#### CITY OF TONTITOWN PLANNING OFFICE

Meeting: **November 1, 2021**Project: **Mathias Warehouses**Planner: Nathan Crouch

#### PRELIMINARY LARGE-SCALE DEVELOPMENT PLAN APPROVAL REQUEST

### Mathias Warehouses Preliminary Large Scale Development Waiver and Variance Requests

L-101

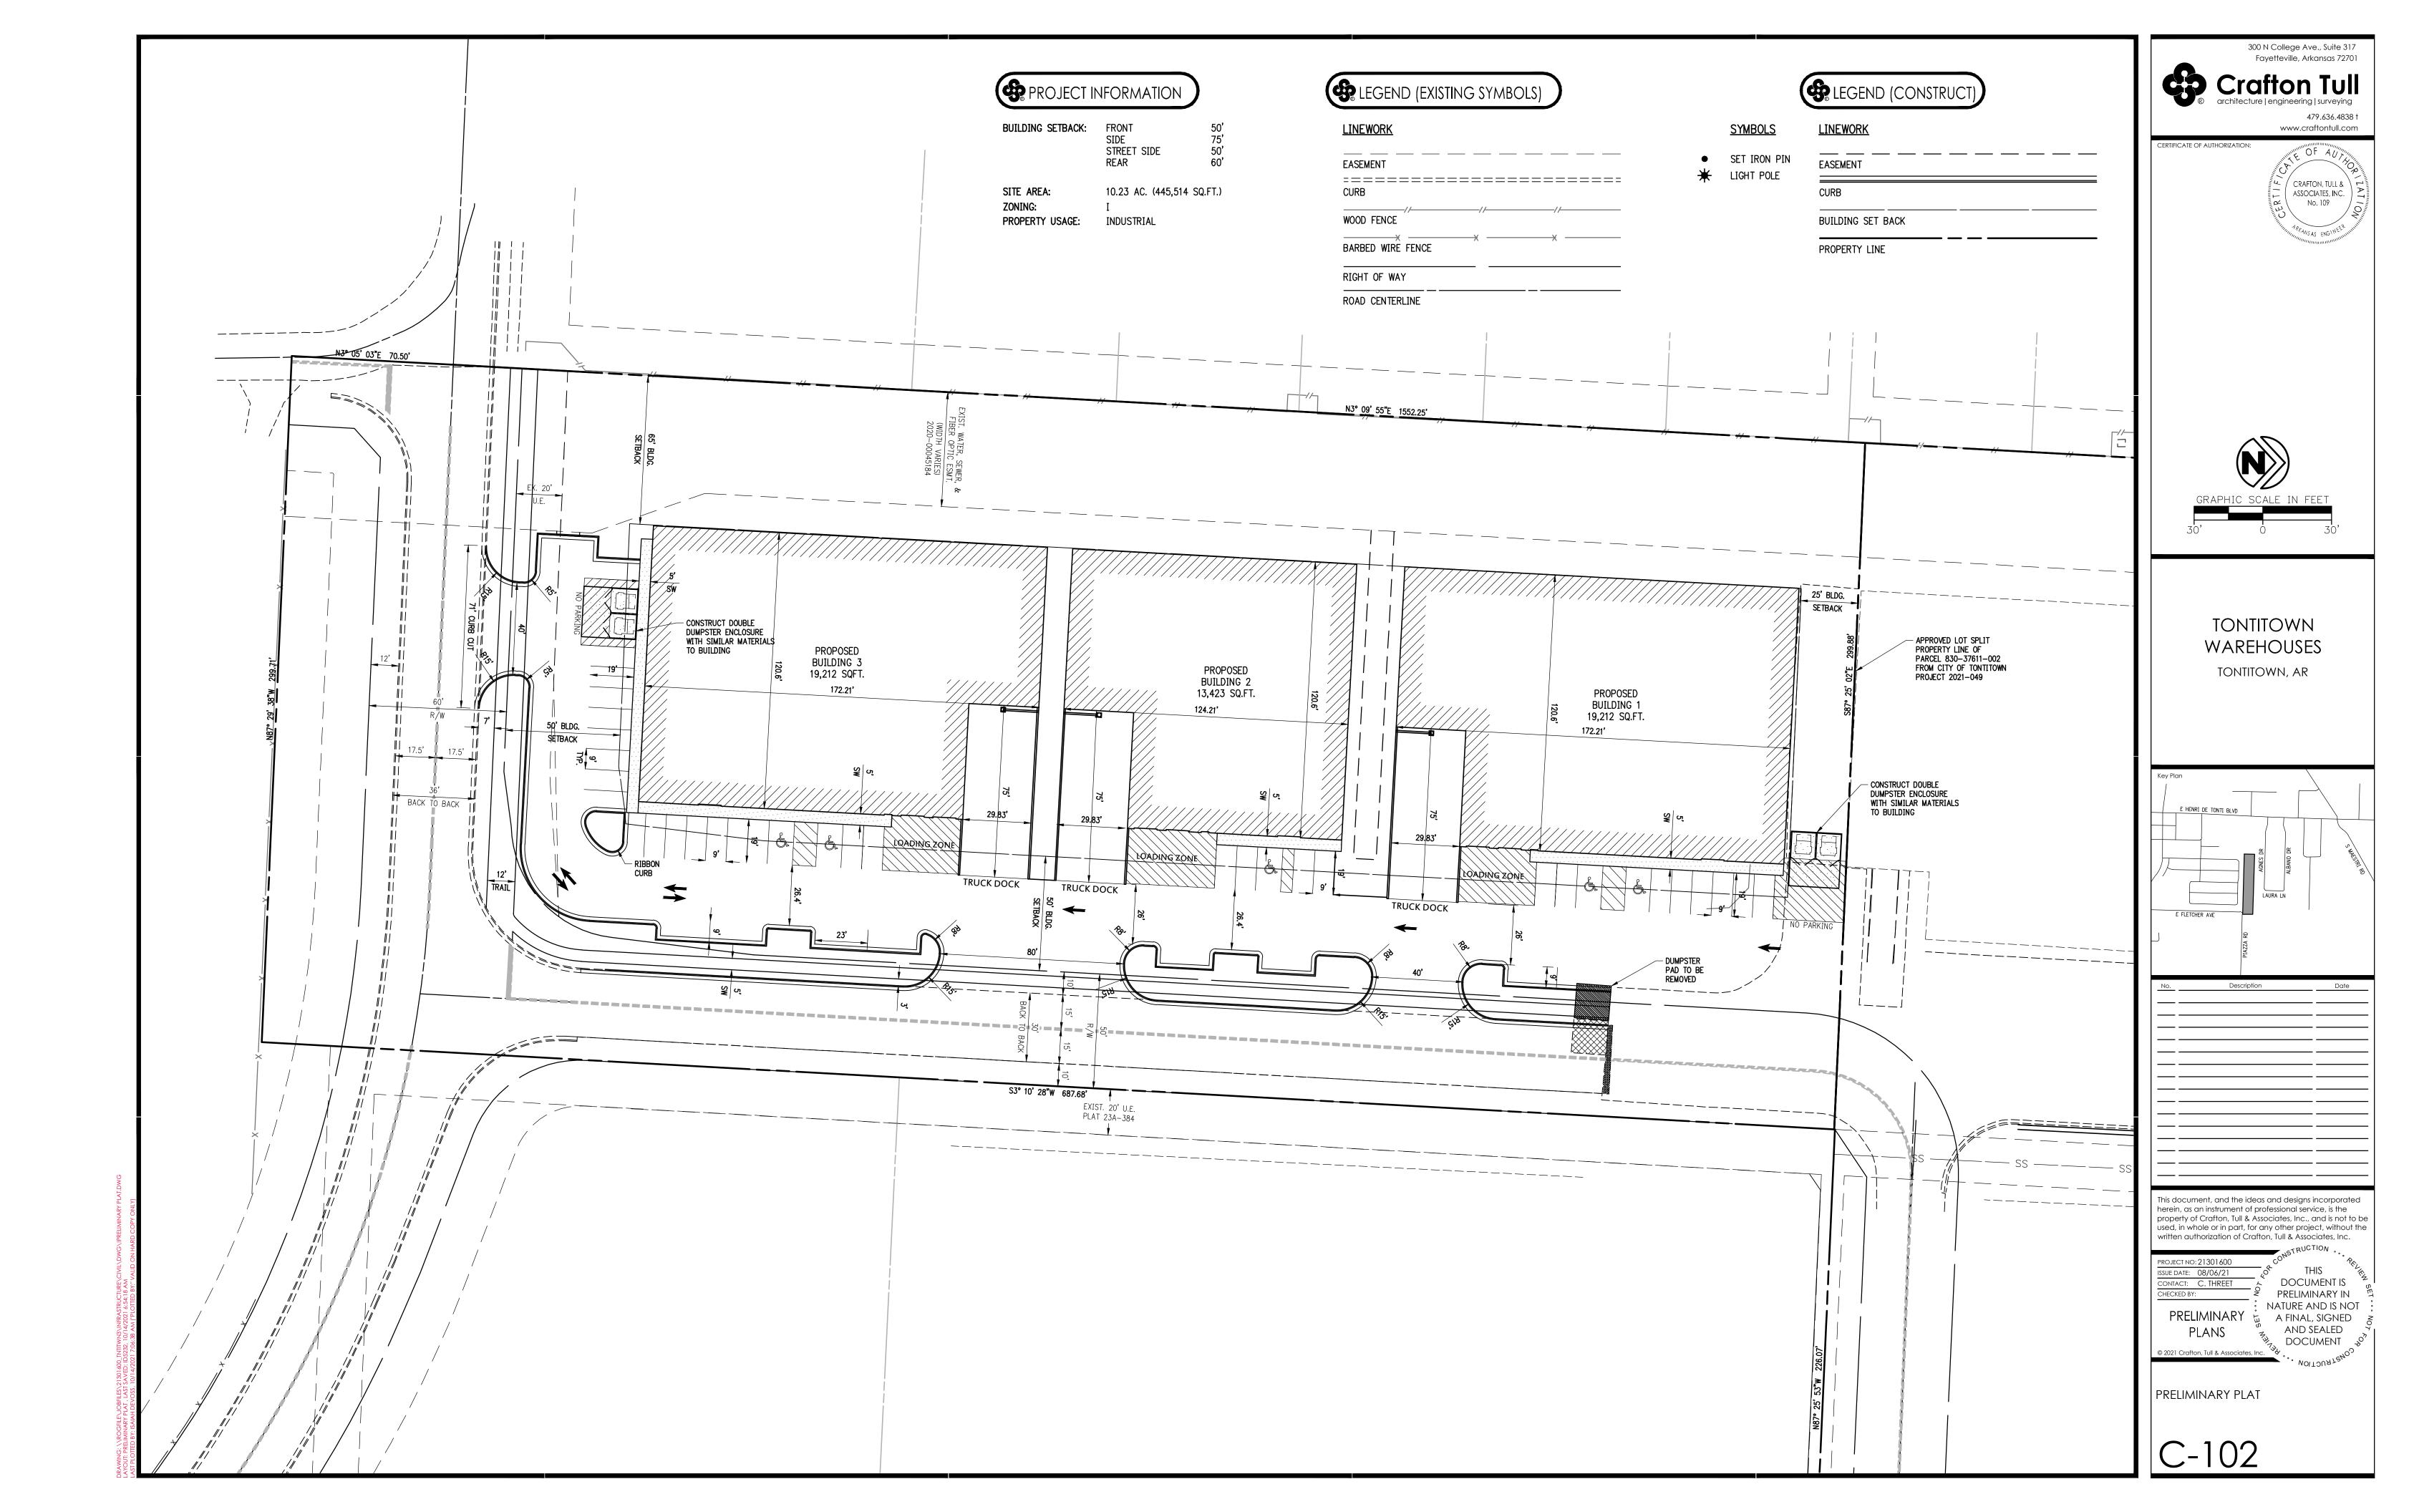
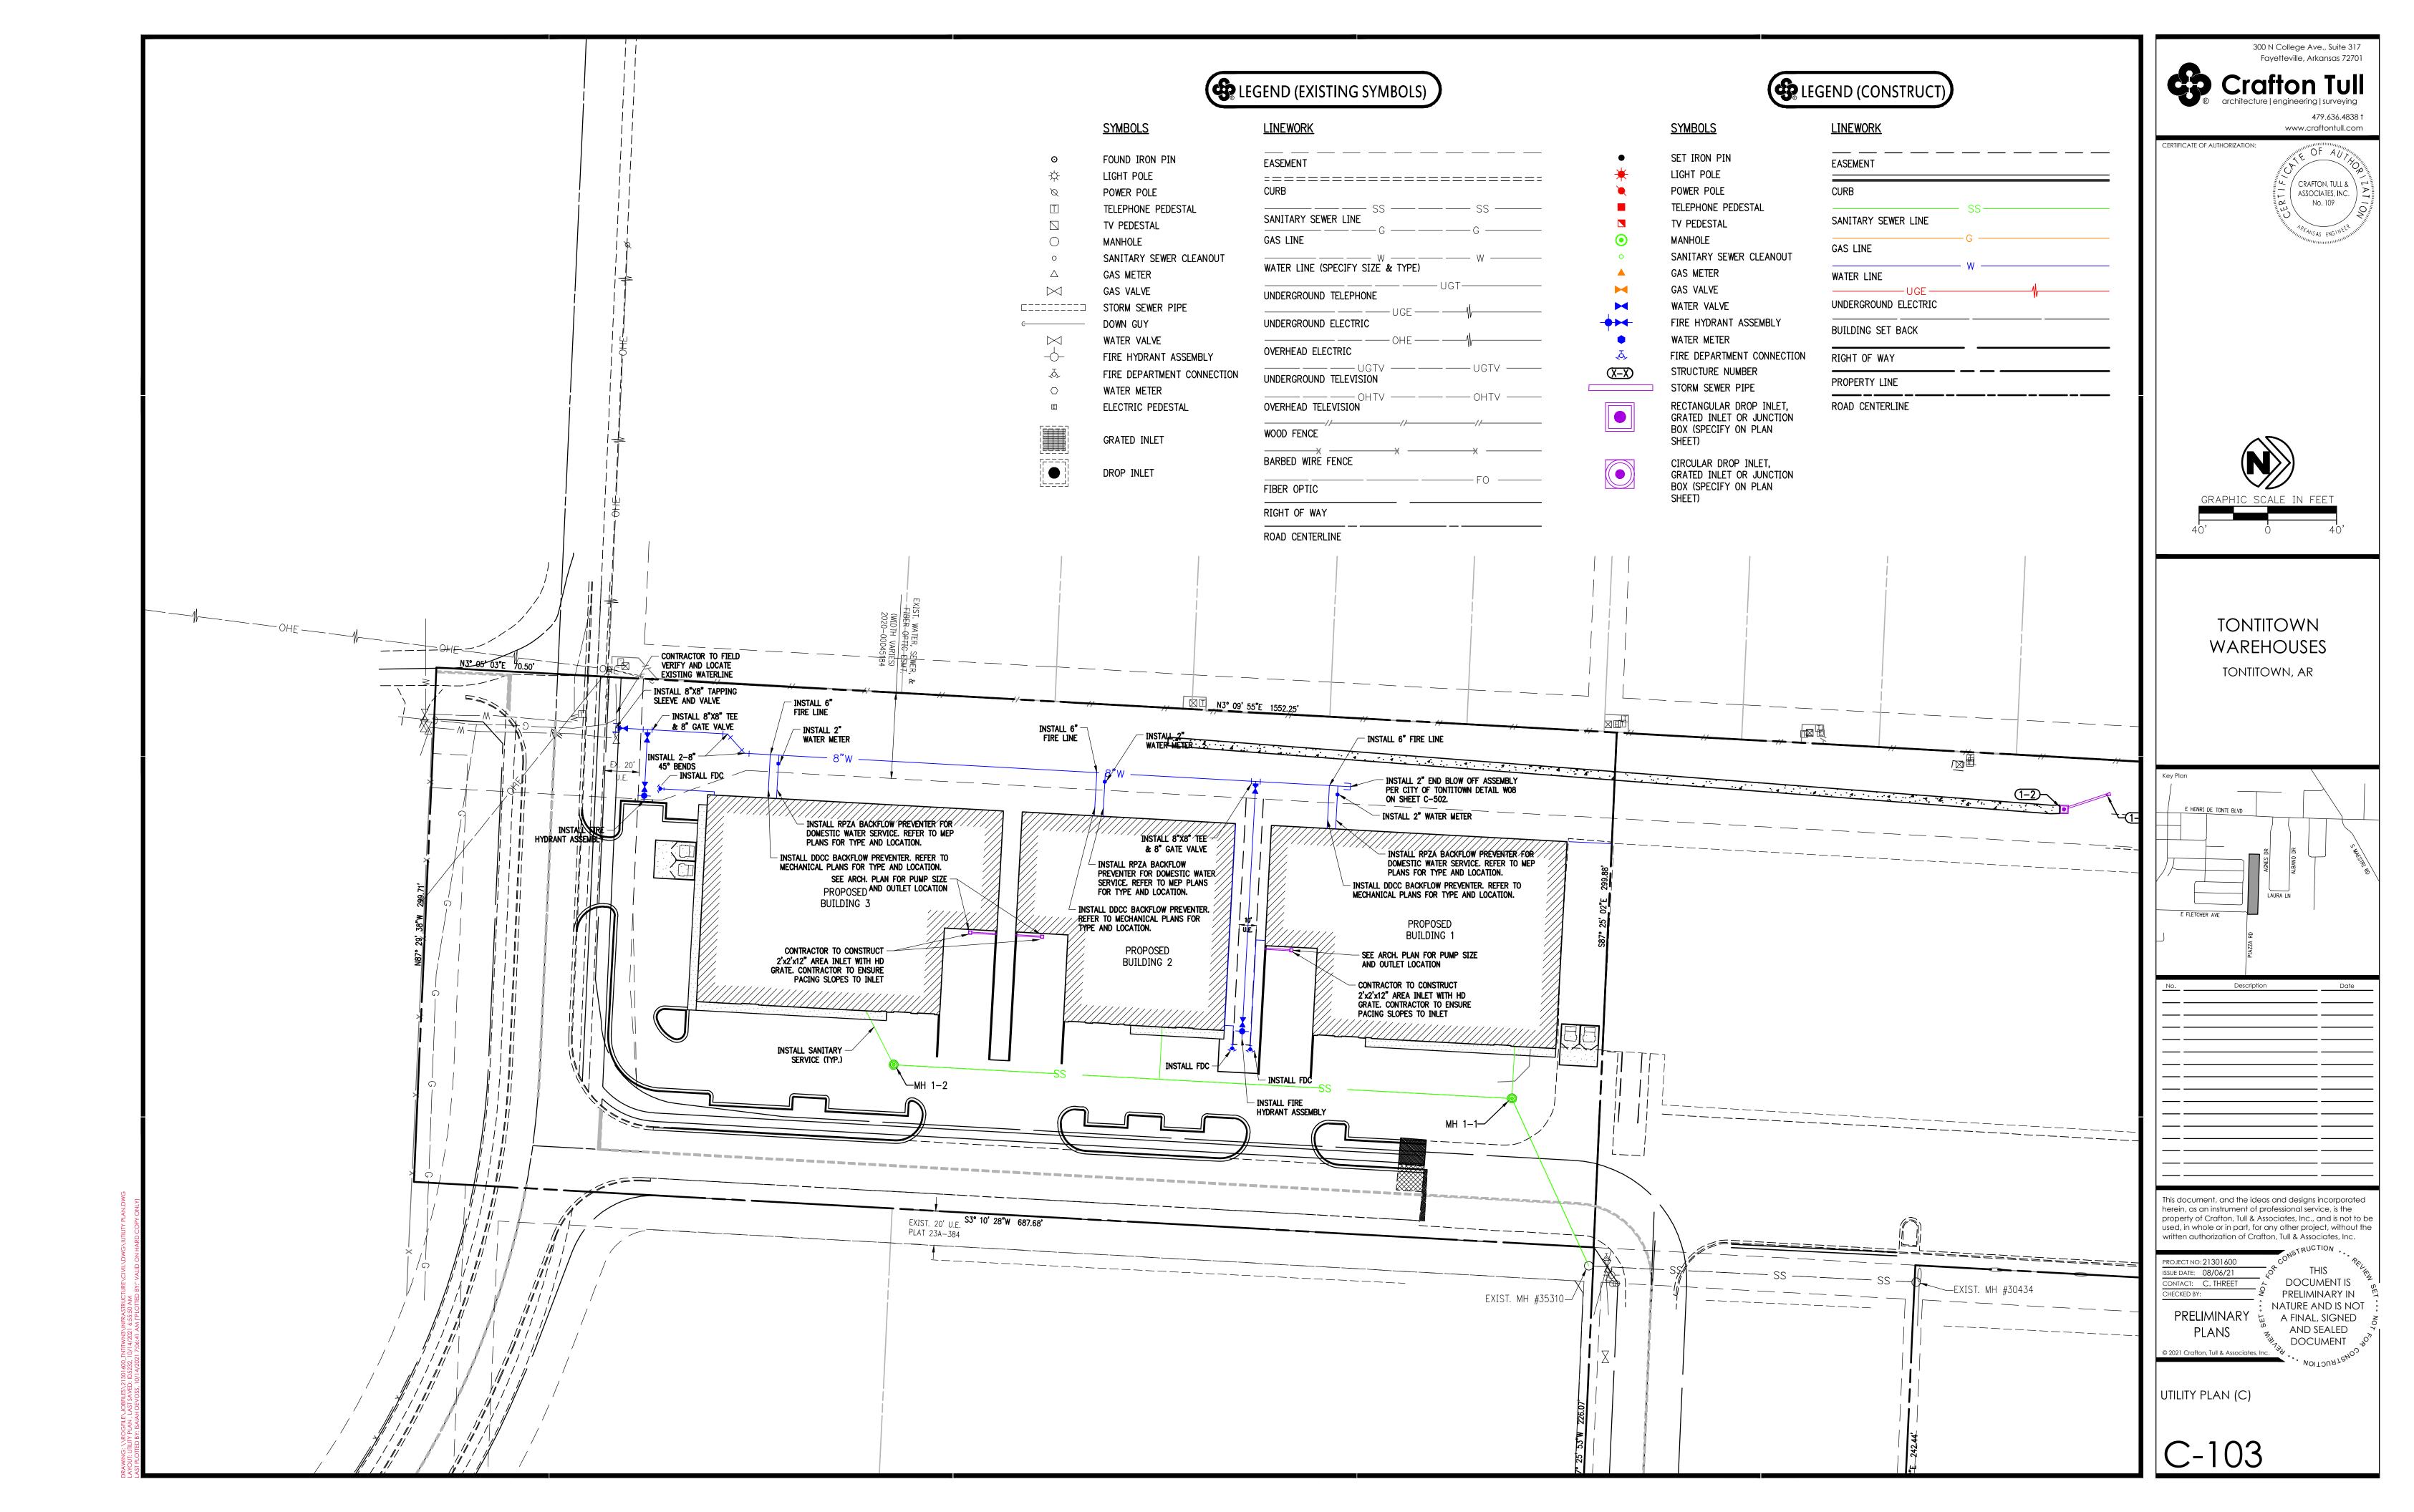
- 7. Provide a drainage easement to the detention pond since a portion of the proposed detention is located on an adjacent parcel.
- 8. Show irrigation method to the proposed landscaping and the landscaped plan must be signed by a landscape professional.
